CITY OF NEW BEDFORD
MASSACHUSETTS
ENGINEERING- 508-979-1550

APPLICATION FOR
CONSTRUCTION OF
PAVED
SIDEWALK/ DRIVEWAY

Driveway Review

Address: 32 Elaine Ave

Sketch

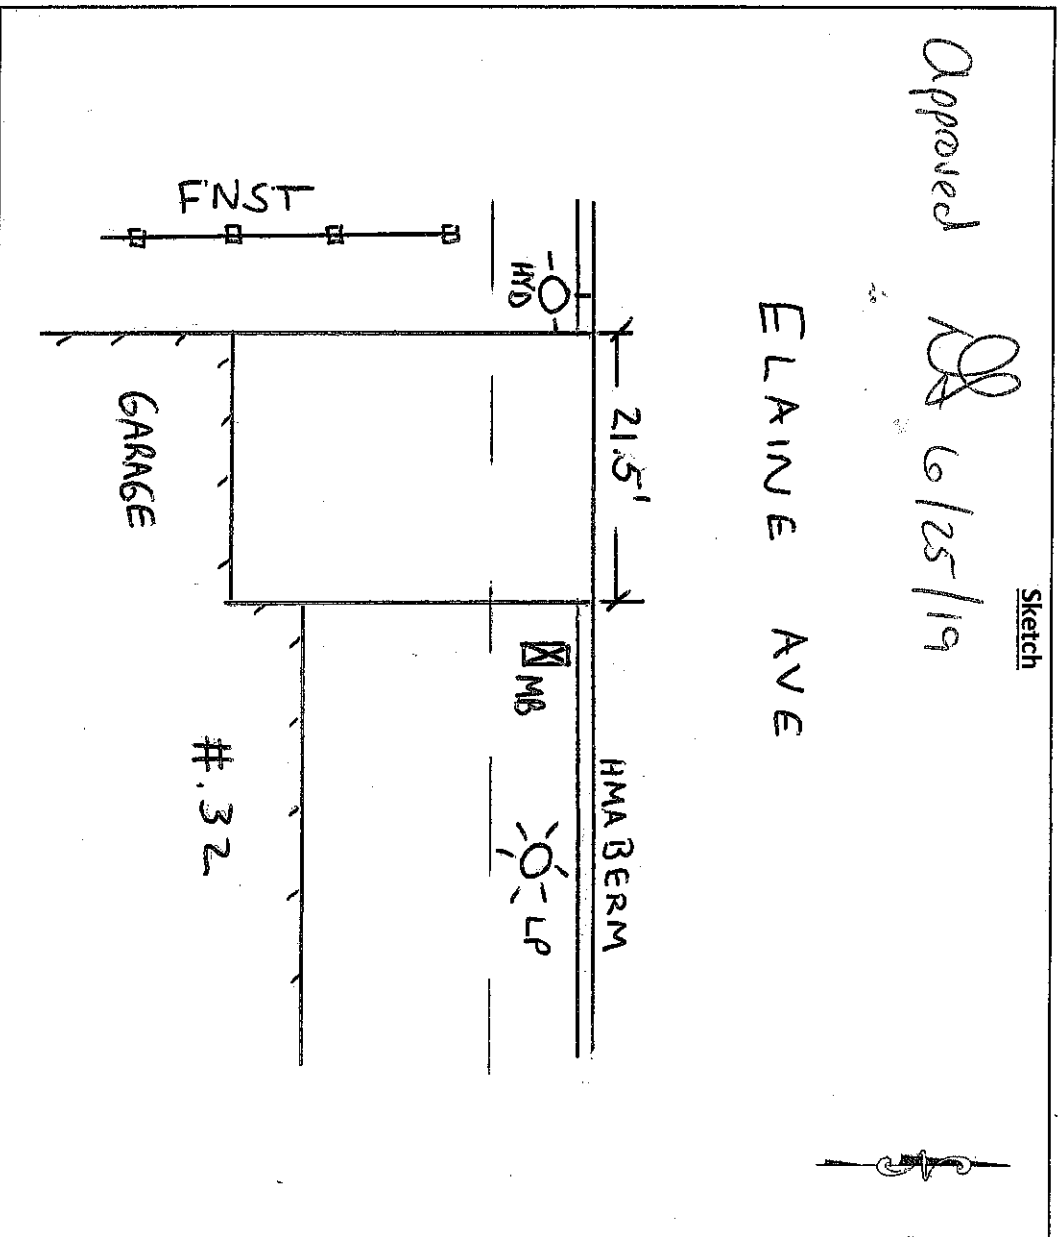
Inspection Notes: - Remove existing 21.5' x 8' HMA Driv Apron

- Install new 21.5' x 8' HMA Driv Apron in accordance w/ the most current DPI Const. Spec's & Standards.
